Monticello Nuclear Generating Plant
Operated by Nuclear Management Company, LLC

MONTICELLO NUCLEAR GENERATING PLANT
Docket No. 50-263 License No. DPR-22

Supplemental License Amendment Request and Response to Request for Additional Information Regarding License Amendment Request for Revision to Standby Diesel Generators Technical Specifications and Surveillance Requirements (TAC No. MB3042)

TYPICAL AIR STARTING SYSTEM SCHEMATIC DIAGRAM

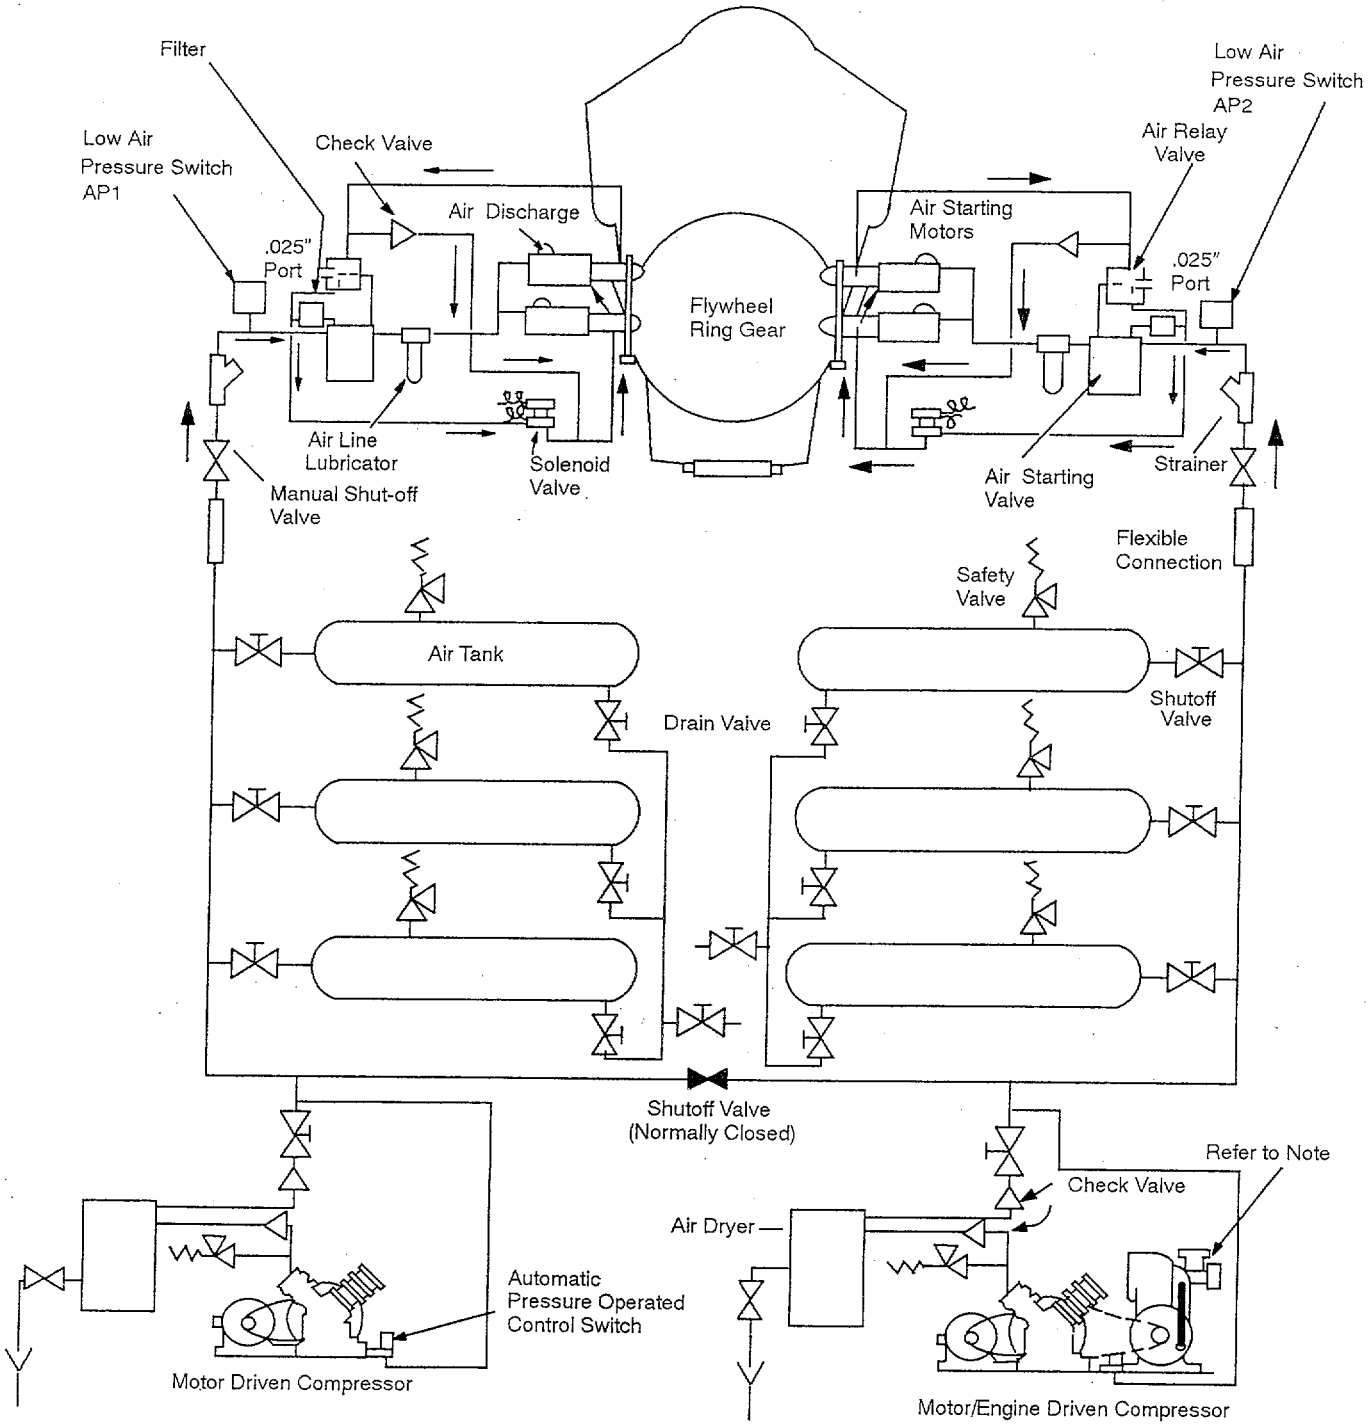
of engine start cycles without recharging the air receiver. Please provide a technical justification for using an off-normal or marginal parameter setting for the proposed LCO and SR instead of the nominal air starting pressure value (i.e., 200 psig).

The rationale for this off-normal parameter for the Technical Specification (TS) Limiting Condition for Operation (LCO) is acceptable because of the operation of the robust starting air receiver system for the Monticello DG. The starting air receiver pressures cited in the Standard Technical Specifications (STS) are plant specific values as denoted by brackets. As discussed above, for Monticello, the minimum pressure of 165 psig for each starting air receiver provides enough air to perform a minimum of at least three (3) starts of the associated DG from each starting air receiver for a total of at least six starts. Additionally, this TS change added a TS LCO and SR for the Diesel Generator (DG) starting air receivers and relocated the existing SR for the air compressors to plant procedures. This repagination, renumbering and rewording provides a TS that more closely models the TS of NUREG-1433, General Electric Plants, BWR/4, Standard Technical Specifications.

c. With both starting air receivers at a pressure ≥ 165 psig there is sufficient air pressure to start the associated DG a minimum of six (6) times. This is acceptable because startup test data shows that each starting air receiver can provide sufficient air pressure for a minimum of three (3) DG starts when starting at a pressure ≥ 165 psig. This more than satisfies the five (5) start design requirement of the DG.
